# **#92-674-100: ENGINE DRIVEABILITY-SURGE AND DETONATION-DIAG. REPLACE PARTS - (Oct 11, 1991)**

**SUBJECT: ENGINE DRIVEABILITY - SURGE HOT/COLD, DETONATION (DIAGNOSIS REPLACEMENT PARTS)**

**VEHICLES AFFECTED: 1987-89 C/K, R/V AND G/P TRUCKS WITH 7.4L ENGINE (VIN CODE "N")**

[Figure 1](#)

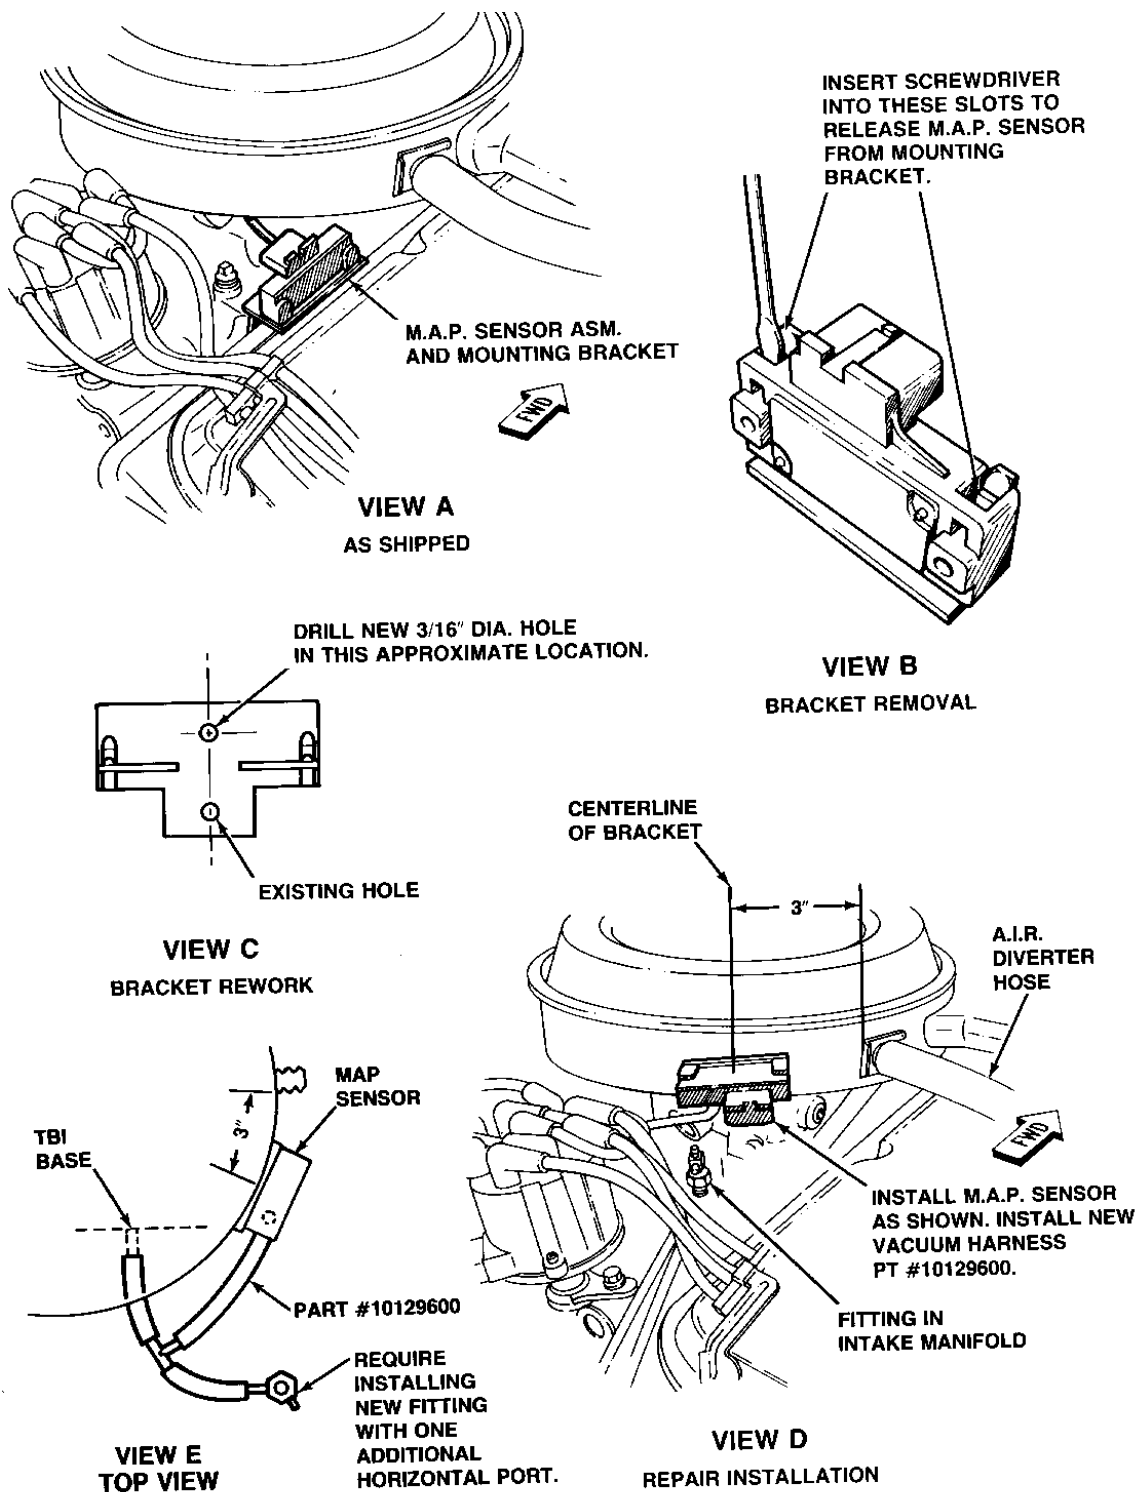
3. On 1987-88 models only, relocate Map Sensor to Air Cleaner.

C. Remove Map Sensor from upper plastic bracket (See Illustration, View B). CARE MUST BE TAKEN TO AVOID BREAKING BRACKET.

D. Remove sheet metal screw holding upper plastic bracket to lower metal bracket, and retain plastic bracket.

E. Add one additional 3/16" hole to plastic bracket and two 1/8" holes in Air Cleaner at proper location using revised bracket as hole template (See View C and D).

F. Mount bracket so Map Sensor vacuum connection faces down toward engine, using two 8-

3x1/2" sheet metal screws, P/N 447164.

G. Install vacuum hose harness, P/N 10129600 (See View D and E).
